Service Bulletin

DB4 Quick-Change Belt Driven Quench Ring Shuttles; Improvements to Drive Belt Joint Clamping Plates

Reference #038

Existing Belt Clamp Plates
845A-770-P133-C

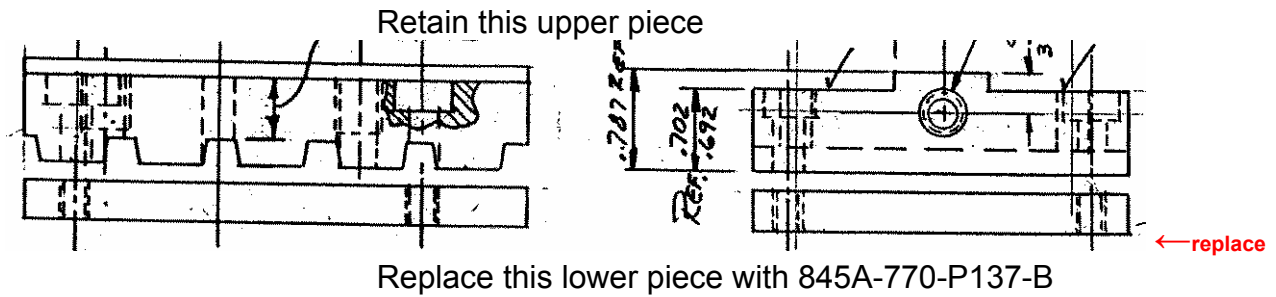
Glasstech has identified a potential problem on the belt-driven DB4 quick-change quench shuttle design with the **loosening of drive belt joint clamp plate** that can lead to a belt joint separation event and accompanying equipment damage. Each of the two ends of both Breco-Flex® shuttle drive belts is currently clamped between two machined aluminum plates using four M-6 metric cap screws. (Reference Glasstech part number 845A-770-P133-C) **It is the tightness of the screws that is the subject of this bulletin.**

- Immediately inspect and tighten existing screws until revised parts can be procured and installed.
- Fabricate or purchase from Glasstech the revised part number **845A-770-P137-B** that is fabricated from cold-rolled steel rather than the original aluminum material. This will allow for the use of a thread-locking compound and additional torque when using longer screws.
- Replace the existing 20mm long screws with longer M-6 x 25mm long cap screws using a thread-locking compound such as ND Vibratite® Formula 3 or an equivalent Loctite® product.
- The new 25mm long screws will be sufficiently long enough to protrude slightly through the P137-B steel clamp plate. **These excess threads should be ground off flush with the clamp plate surface.**

NAME BELT CLAMP PLATE	
CRS	
SCALE FULL	
DRAWN BY HM	DATE 9 OCT 02
CHECKED BY	DATE
GLASSTECH, INC.	
DRAWING NO. 845A-770-P137-B	REV.

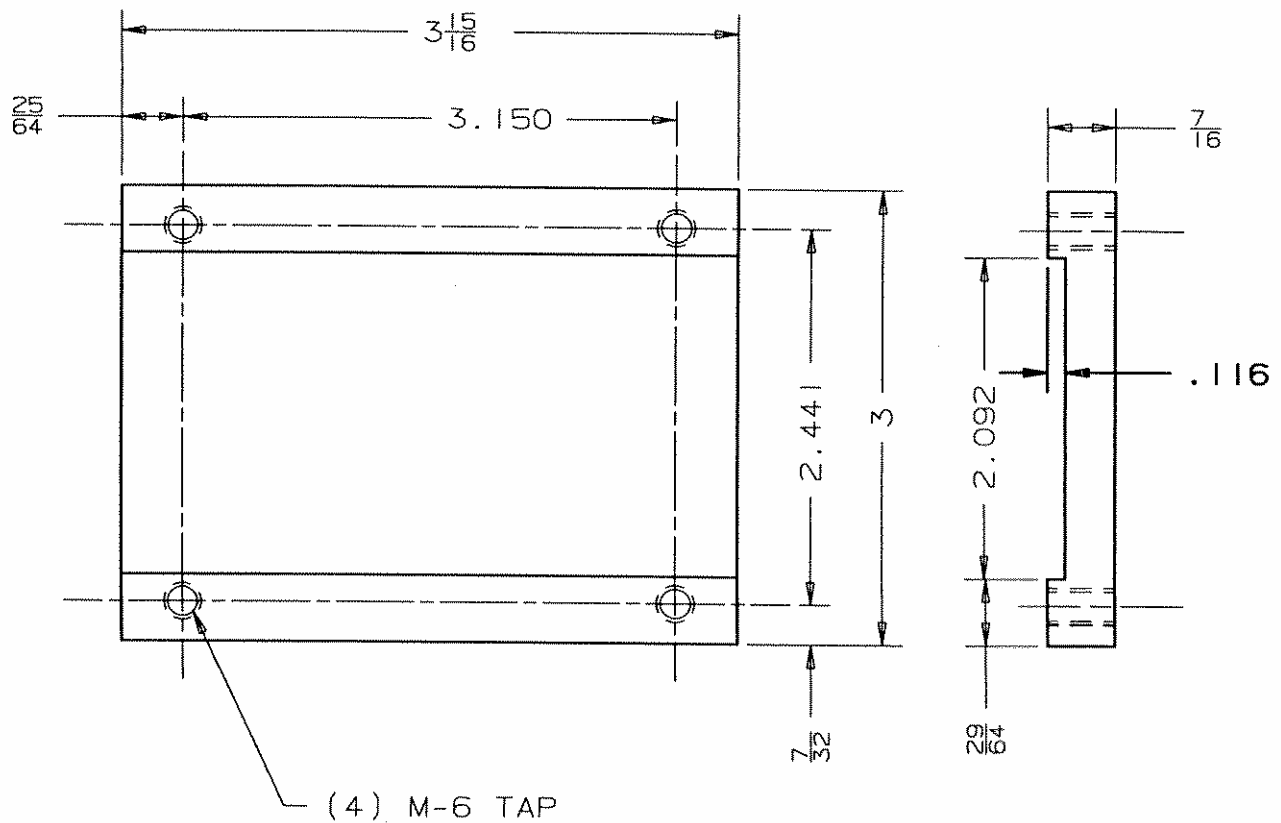
The attached drawing details the re-designed part that is intended to replace the original aluminum clamp plate.
